ATTACHMENT 'B' TO AEP:NRC:00313

REVISED TECHNICAL SPECIFICATION PAGES

DONALD C. COOK NUCLEAR PLANT UNIT NOS. 1 AND 2

CHANGE NO. 1

Figure 3.4 - 2 DONALD C. COOK UNIT NO. 1 REACTOR COOLANT HEATUP LIMITATIONS APPLICABLE

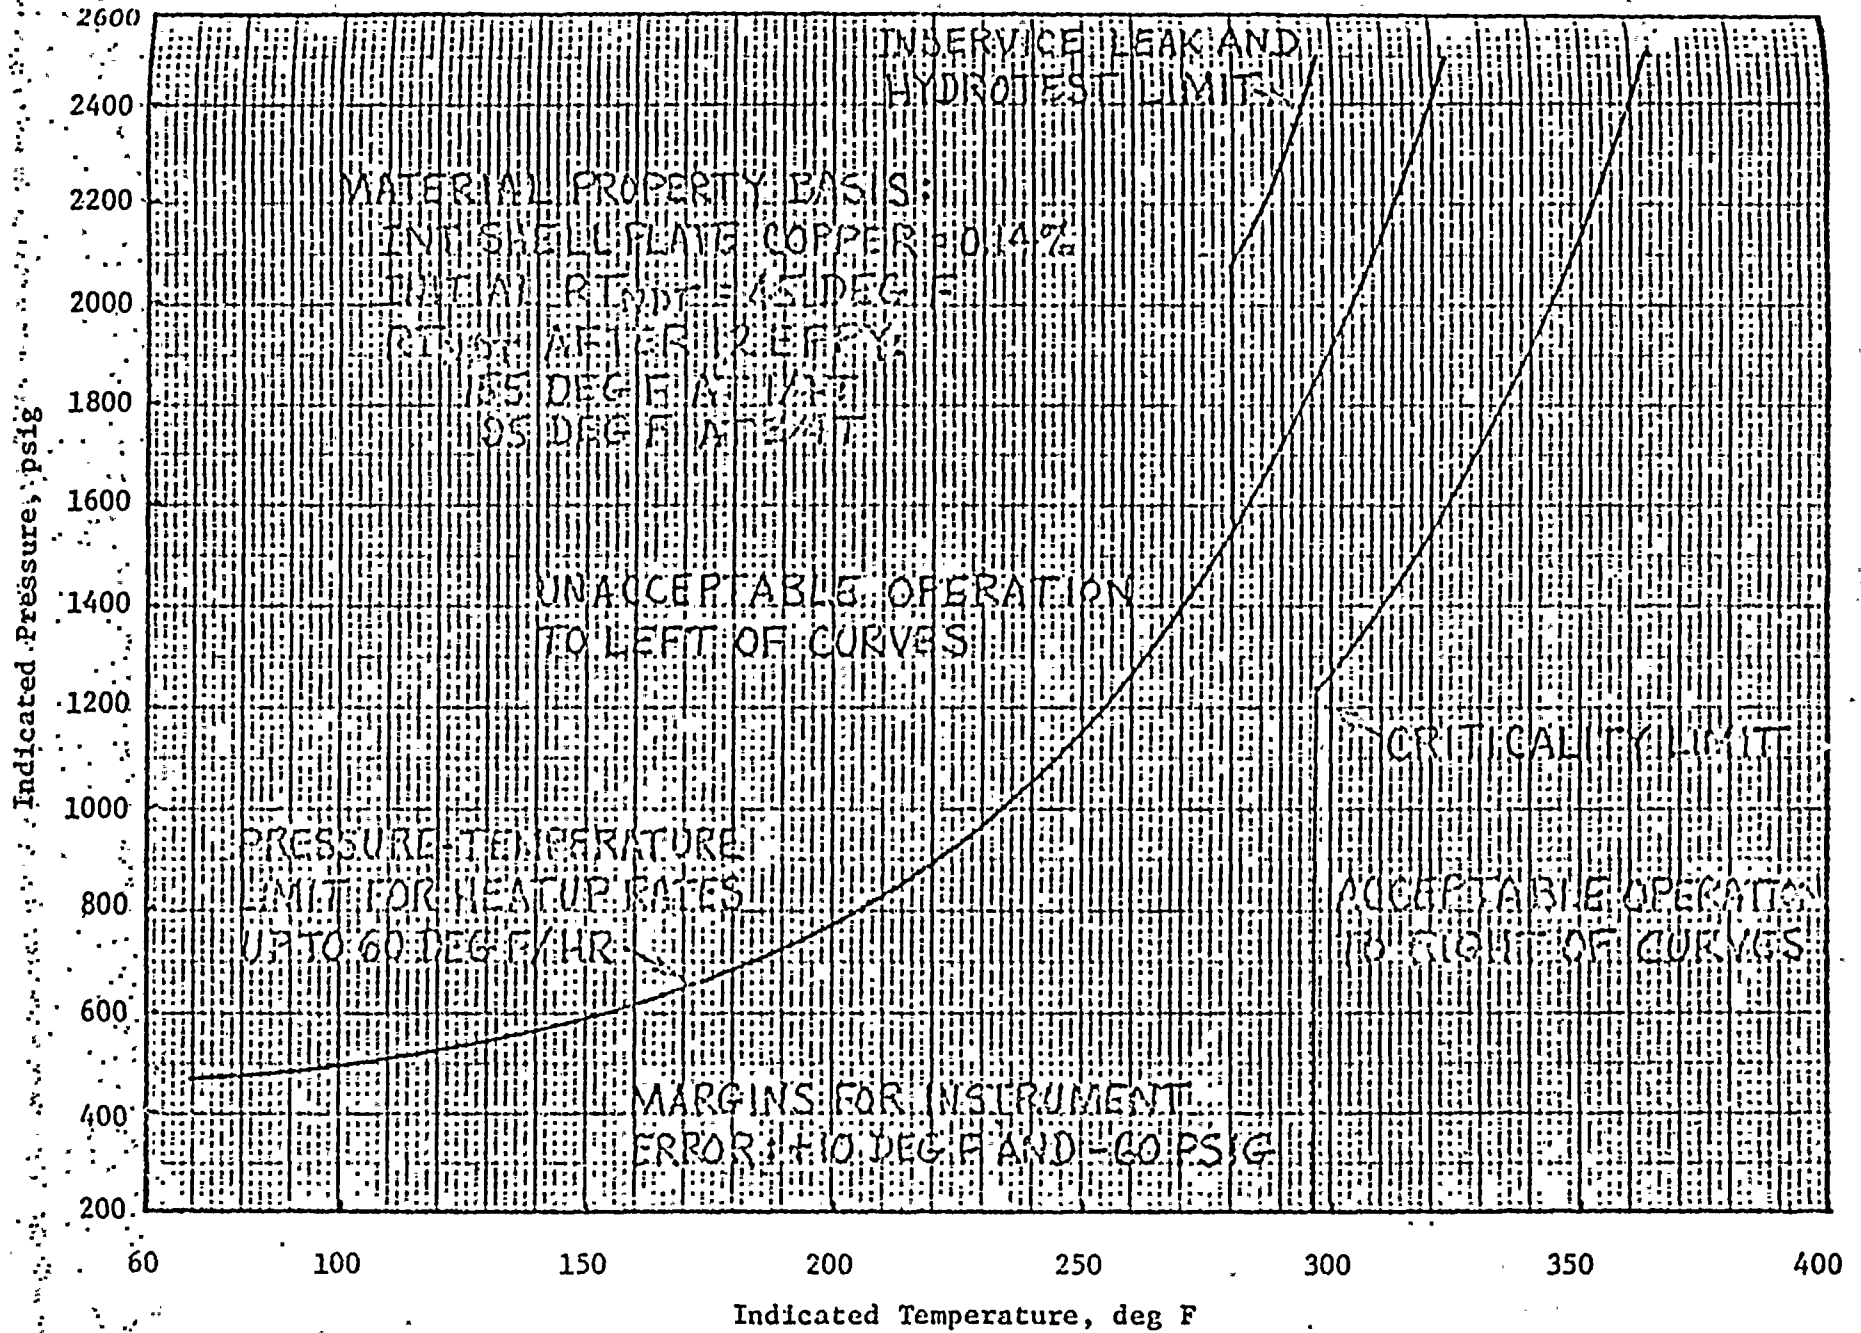
CHANGE NO. 2
